## HISTORIC AND DESIGN REVIEW COMMISSION

**HDRC CASE NO:** 2022-150  
**ADDRESS:** 504 KING WILLIAM  
**LEGAL DESCRIPTION:** NCB 749 BLK 8 LOT 9,10, NW IRR 28.2FT OF 1 & NW 61.2 FT OF 2  
**ZONING:** RM-4, H  
**CITY COUNCIL DIST.:** 1  
**DISTRICT:** King William Historic District  
**APPLICANT:** Daniel Cruz/Design Coop  
**OWNER:** Christopher Guerra/LAUREL HEIGHTS FAMILY IRREVOCABLE TRUST  
**TYPE OF WORK:** Installation of a wood pergola in the rear yard  
**APPLICATION RECEIVED:** February 28, 2022  
**60-DAY REVIEW:** Not applicable due to City Council Emergency Orders  
**CASE MANAGER:** Jessica Anderson

1. Install a wood pergola on the rear balcony.
2. Install a wood pergola at the rear elevation.

**Historic and Design Review Commission**  
***Design Review Committee Report***

**ELEVATION:** REAR ELEVATION, PROPOSED PERGOLA  
 SCALE: 3/16" = 1'-0"

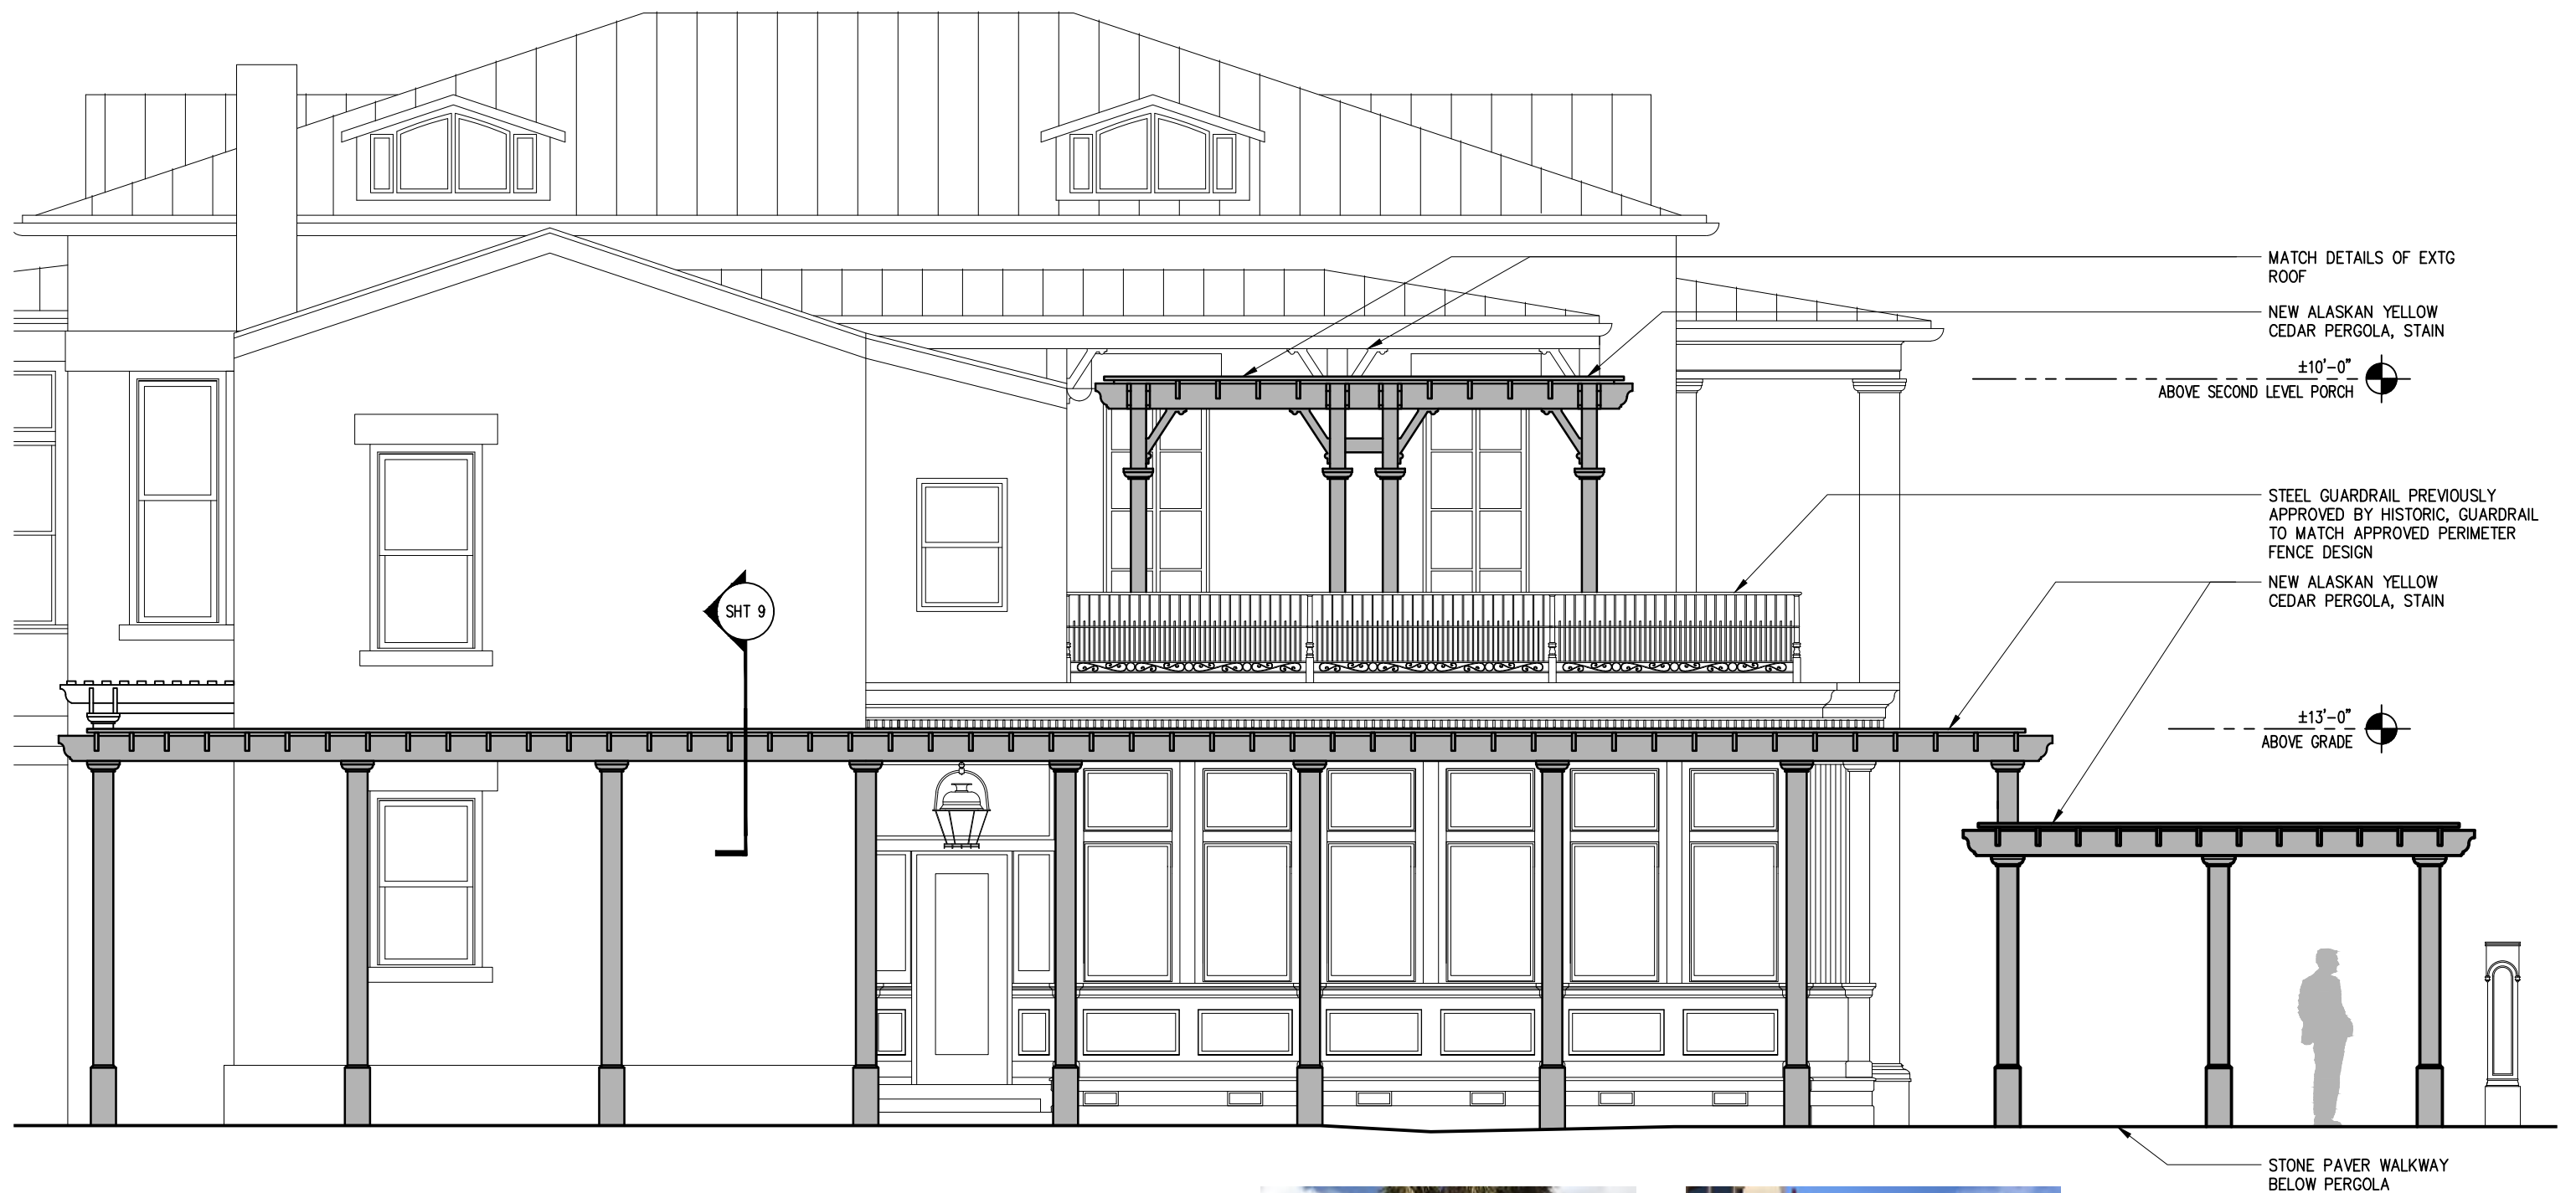
Carpenter: The other elevation—lower pergola picking up on rhythm of structure of main house. But feels confused in structure bays. Seem to be lack of geometric integration in elevation (p 9 in case file).

Carpenter: and limestone is like a sponge. If metal corrodes, become chisels internally and breakup walls. Why does the pergola also step in and down? Why not carry down line of columns?

Cruz: Existing concrete walkway there that they'll bring back. Trying to keep these elements. Didn't want to increase impervious cover size, so decided to narrow pergola.

**SECTION:** PERGOLA CONNECTION AT EXTG RESIDENCE  
SCALE: 1 1/2" = 1'-0"

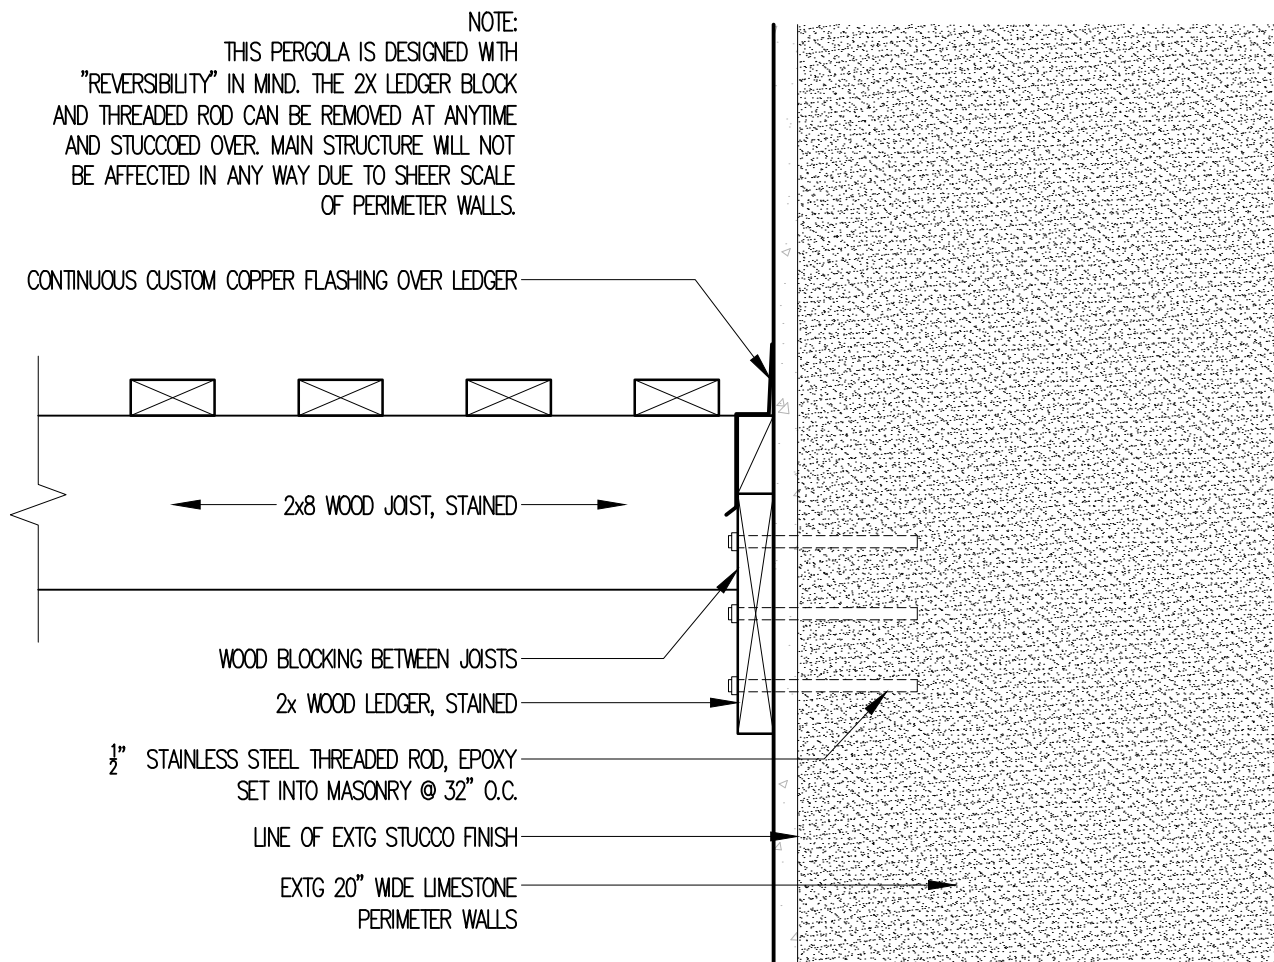
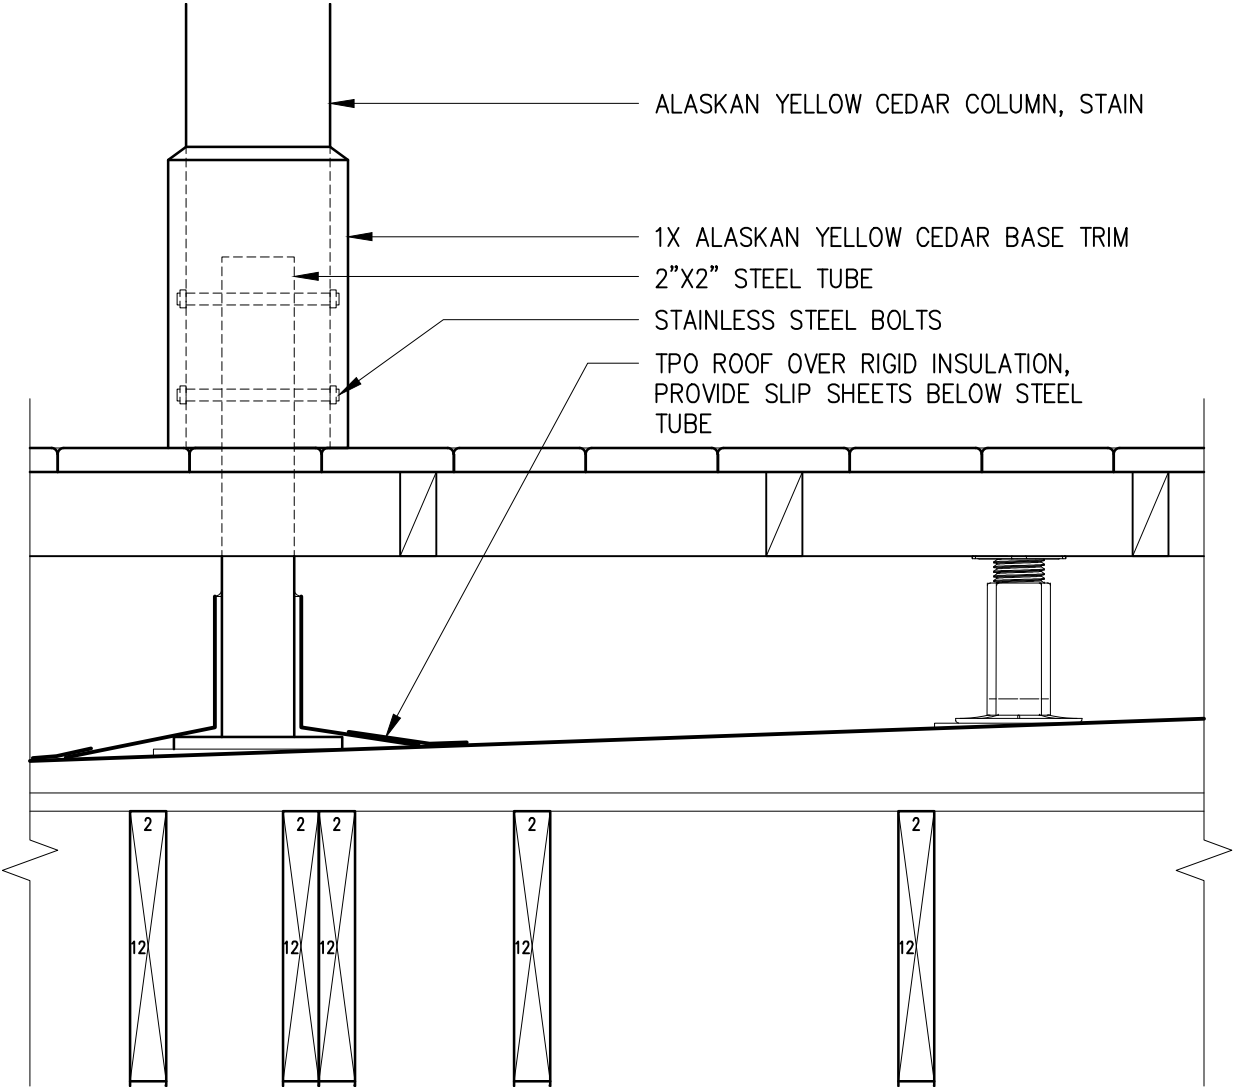
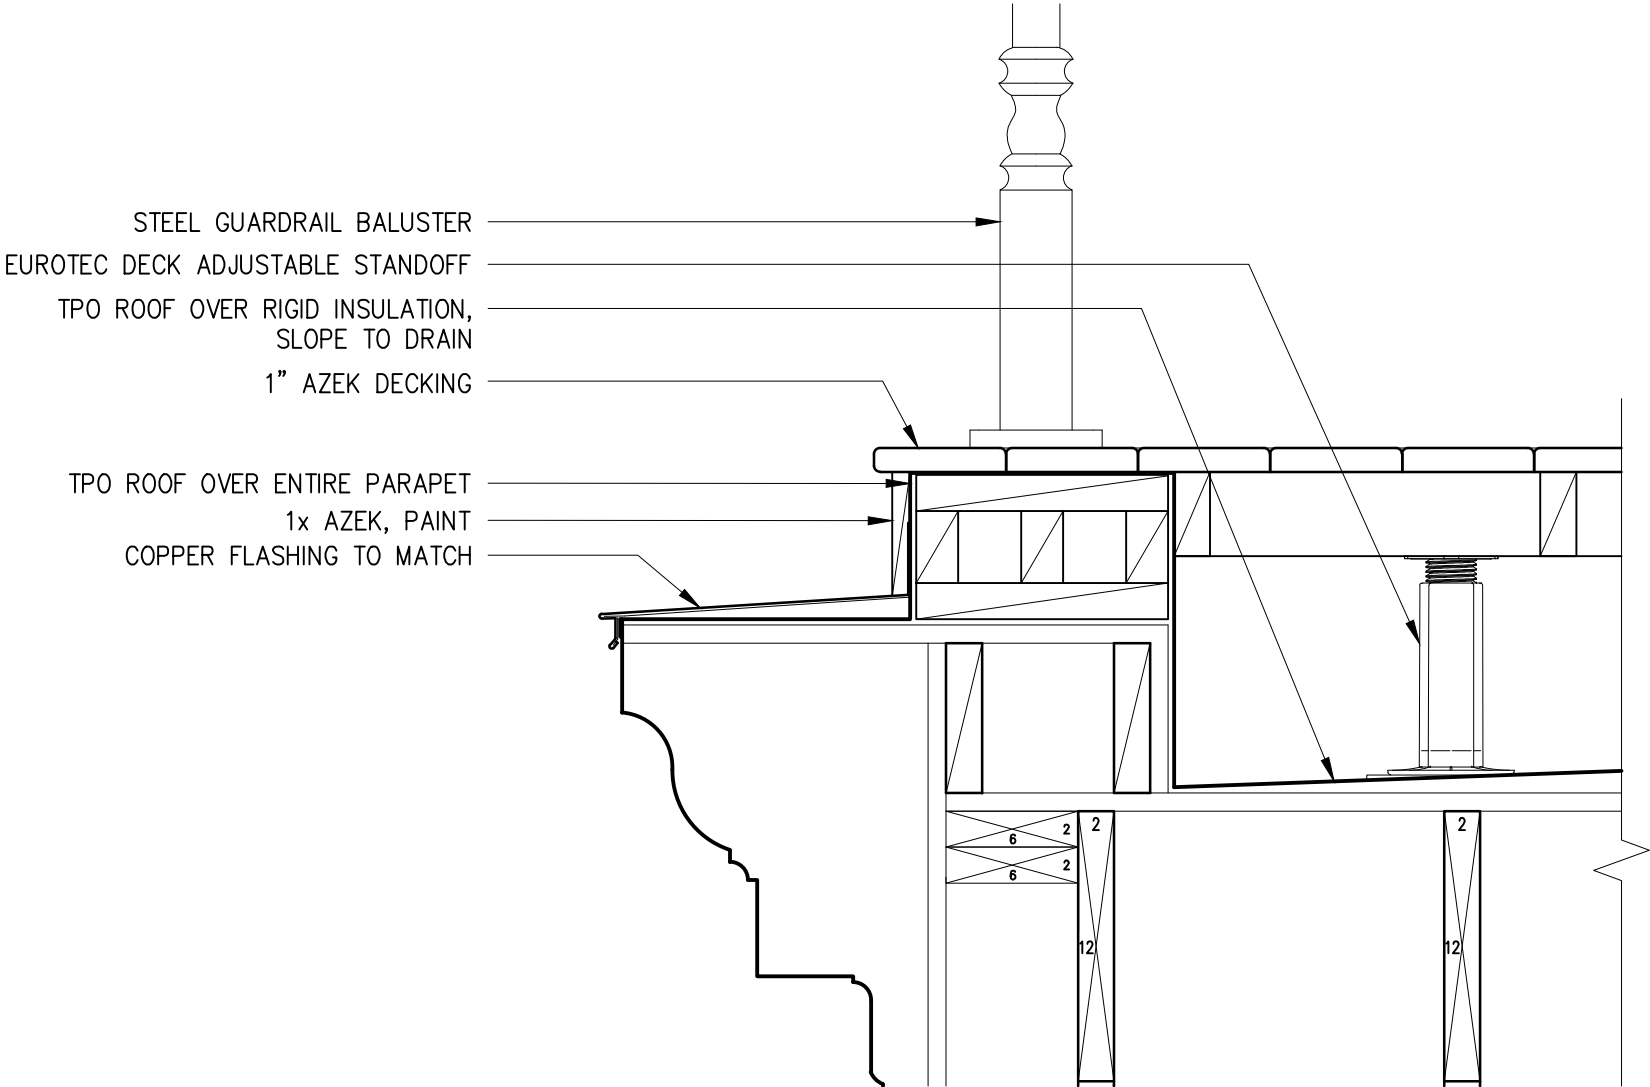
Carpenter: Connections into masonry walls—done very surgically, into masonry joints rather than into units. If removed, can just repoint mortar joints. Not just thinking for this owner, but future owners and architects.

Savino: Make a point to spec the correct fasteners—stainless steel. Even though we don't have high moisture in our climate, finds a way into penetrations of wall.

Savino: Having details and sketch and calling out fasteners, neoprene seals, etc would be very important to include.

- i. That the pergolas are installed so that they are a reversible condition and are independent structures that do not require attachment to the primary structure. The applicant must submit updated installation plans to staff for review and approval prior to the issuance of a Certificate of Appropriateness. (The updated drawings reflect this stipulation.)
- ii. That the applicant submits a final landscaping plan showing the material and dimensions for all proposed site work and total percentage of lot coverage to staff for review and approval prior to the issuance of a Certificate of Appropriateness. (The updated drawings reflect this stipulation.)

Cruz: Solid limestone structure, but has 1-2" plaster veneer/stucco finish. Smooth plaster finish with faux stone layout. Can install threaded rods as needed, then remove and waterproof accordingly without damage to structure.
